* User name: SHAW (11) Queue: UIDEK/UNIX_UIMKGT
 * File name: Server: CLFPCD010
 * Directory:
 * Description: NORDIC40.
 * December 21, 1998 5:46pm

Cirrus Confidential
Business Information

DELTA LIST OVER PREVIOUS PINOUT RELEASED ON :

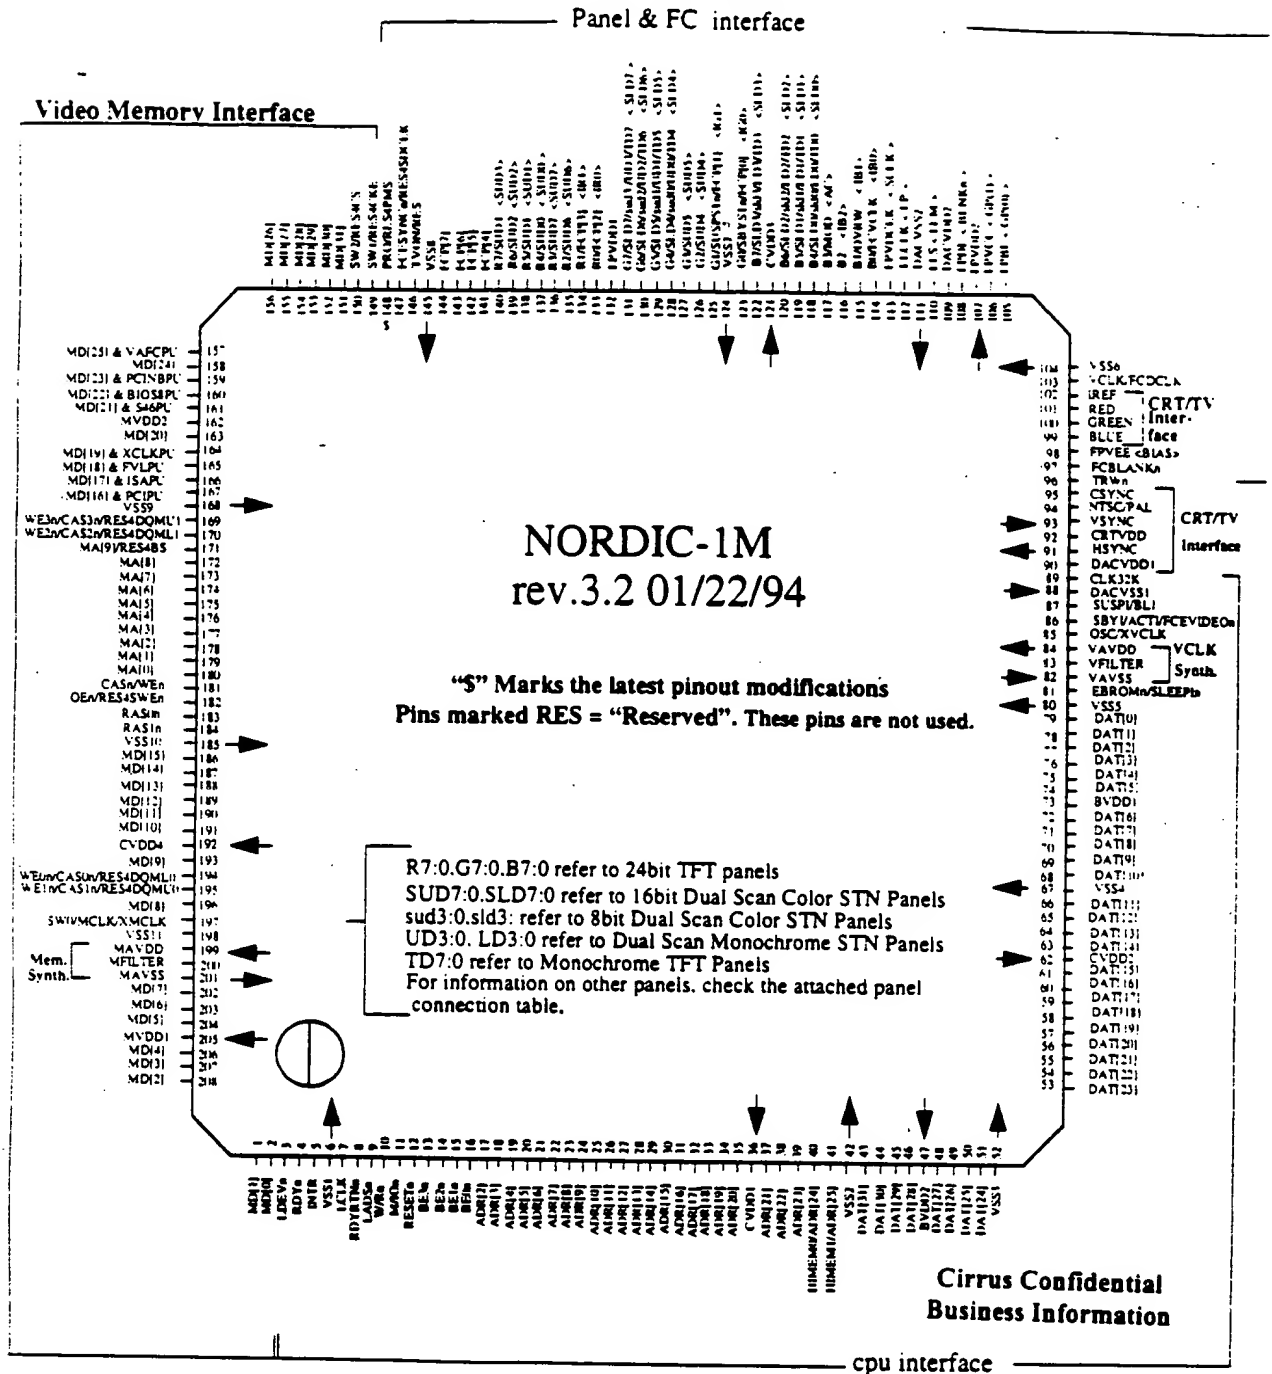
- no POUT on SW2/POUT
- XVCLK moved from SW1/VCLK/XVCLK to OSC/XVCLK. This way SW1/VCLK/XVCLK became SW1/VCLK.

- All panel pins whose names were not starting with the color panel name were changed such that the names start now with the color panel pin (R7, G7, B7 and so on). So it was only a pin name change.

1. Took-out Whisper Support Pins: WWRn, WRdn, WAD[3:0], FPCn.
2. Reduced the number of CPU Address Pins: ADR[24:27] went-away. Use HIMEM to place the chip outside 16MB of memory for linear addressing.

3. Killed CRTVDD and placed CRT Interface on Host Bus VDD.
4. Introduced VAFC pins in a unique pinout configuration in both VESA VL and PCI.
Added VAFCPU a pull-up to enable VAFC (VESA Advanced Feature Connector).
ADR[27:24] become VAFC pins, and R[7:4], G[7:6], CLK32K, SUSPI/BLI, SBYI/ACTI get a configuration for VAFC -> total 14 pins.
SW0/VCLK will be used as VAFC DCLK, losing SW0 pin as panel type when VAFCPU is used.
In PCI bus, no ADR pin will be shared with VAFC.
ASW0PU will be added on MD pins to replace SW0 pin when VAFC is enabled by VAFCPU. SW0PU will read-back in the same register bit as SW0, so the BIOS will not feel any modification in the reporting scheme.
The chip will draw more power in suspend with VAFC.

5. Moved SW2, SW1/MCLK/XMCLK, the two RESERVED pins and TRWn on MVDD to prepare for SDRAM pin compatible option in the next Nordic that supports SDRAMs. It looks that we need only 3 more memory pins to support SDRAM-s so TRWn will not be used. It was moved so it is on the right VDD bus if needed.

6. Moved CVDD3, VSS3, VCLK Synth, H/VSYNC, EROMn, SW0 per Thomas Hung's request to fit the floor plan.

1. Added AUXS1 on D/Cn as an option to be used with CS4231S as CS.
2. Added AUXS2 on EROMn/VADRn as an option to be used for Sound Synthesizer Chip Select.
3. Rearranged 5428 FC pins due to a previous error : R5 and R4 should not be used with FC.
 - FCP[1:0] are shared with G7 and G6.
 - SW2 and the two pins reserved for SDRAM were moved in between Video Memory pins and Panel pins and one of them is used as FCESYNcn.
 - OVRW is shared with CLK32K, FCBLANKn is shared with SUSPI and FCEVIDEn is on SBYI.
4. Renamed the External Clock PU XCLKPU instead of XMCPU.

1. Moved some external pull-ups.
 2. Added alternate pin functions on panel pins as well as actual schematic name for engineering
- 10/27/93
1. Added TV-OUT (called also NTSC-OUT) pins on the panel pins

1. Added TVG on EBROMn/AUXS2 and took out VADR as an option on this pin.
2. Put back FCESYNcN on RES4SDCLK as an option (deleted by mistake).

1. Reset became RESETn, active L to correspond with the defined reset signal for VESA VL and PCI.
2. TFT Panels Data Pins R7:R0, G7:G0, B7:B0 changed and all pins got rotated to get them ordered from right to left. Due to this change now Ri=TVRi, Gi=TVGi and Bi=TVBi.

1. Update Panel Data Pins based on Robin's Table.
2. Move MOD pin on a Panel Data Pin used in 18bit TFT.
3. Move OVRW on a 24bit Panel Data Pin.
4. Removed pin configuration for TV-OUT support with digital encoders. All pins marked TV... were removed. As a result, some pins like LLCLK, LFS, FPDE, FPVDCLK have one function now.

5. Removed WavePort pins, including AUDVDD: total 7 pins freed.
AUX2 and TVG muxed on EBROMn are no longer needed either.
6. Added one more CPU address pin: instead of HIMEM, Nordic has now HIMEM0 and HIMEM1, corresponding to CPU Address 24 and 25 or any other external decode of the high order CPU address bits. In the process of adding this pin, most CPU Interface pins on the right side were moved to the right by one pin.

7. Added CRTVDD supplying HSYNC, VSYNC, CSYNC, NTSC/PAL CRT and TV Interfaces output buffers.
8. EBROMn is shared with TVON, the power-on signal for AD720. So, in ISA bus with on chip BIOS support, AD720 power on cannot be directly controlled by Nordic.

9. Added pins for Analog TV Encoder support - AD720 and MC1377 :
 - a. CSYNC = Composite Sync signal
 - b. NTSC/PAL = 1 -> NTSC, 0-> PAL (for AD720, but it is TV Encoder Dependent)

- c. EBROMn/TVON (see #8).
10. ASW0PU "Alternate Switch 0 Pull-Up" pull-up on pin 155. MD[26] was removed, as SW0 is now not multiplexed.
11. De-multiplexed some of the pins previously multiplexed:

- a. Pin 168 TWRn/RES4PMS is now RES4PMS, a pin reserved for synchronous DRAM support.
 - b. SUSPI/BLI/FCBLANKn is now SUSPI/BLI, not affected by the Feature Connector Enable Configuration

- c. As a consequence of b, pin 97 is FCBLANKn (not muxed with anything).
Please note that FCEVIDEOn is still muxed with SBYI/ACTI as before, as Standby Input and Keyboard Activity are less important functions in a system.

- d. SW0 is no longer muxed on VCLK/FCCLK. So VCLK/FCCLK is a pin but it moved to pin 103 in the PVDD area, to be consistent with FC power supply.
12. SW1, muxed on MCLK/XMCLK (pin197) became SW0. This is just a name change to have the switches placed in a more consistent manner.

13. SW1 is now muxed with a reserved pin: RES4CKE, pin 148, which before was totally reserved. The idea here is to go for pu/pd with SDRAM-s for SW2 and SW1, while keeping SW0 on MCLK even with SDRAM-s.
14. Pin 147 is Reserved. It is actually one of the WavePort pins, but placed in-between Memory and Panel VDD busses (on MVDD) for maximum flexibility. To achieve this, the pins on its right were moved to the right by one FPVDD <BIAS> moved down to pin 98 (it was 105).
15. TRWn is now by itself on pin 96, on FPVDD.
16. The names of all flat panel data pins reflect the panel type table attached to this document.

1. On EBROMn/TVON -> EBROMn/SLEEPIn with SLEEPIn an input which if L puts Nordic to sleep (as 3C3[0] and 46E8(3).
2. TVON is now on RES, but TVON/RES is pin 146 and FCESYNc/RES4SDCLK is pin 147.

1. Pin 148, RES4PMS which was a pin reserved for synchronous DRAM-s, got a function: it is now a programmable output PRO and it is on FPVDD instead of MVDD. The intention is to optionally use this pin to control a switch between 5V and 3.3V, in which case a H level of 5V is desirable. My primary choice for this function is actually NTSC/PAL pin which is on CRTVDD, but if the TV-OUT option is used in a system and a switch between 5 and 3.3V is provided, PRO may be used.
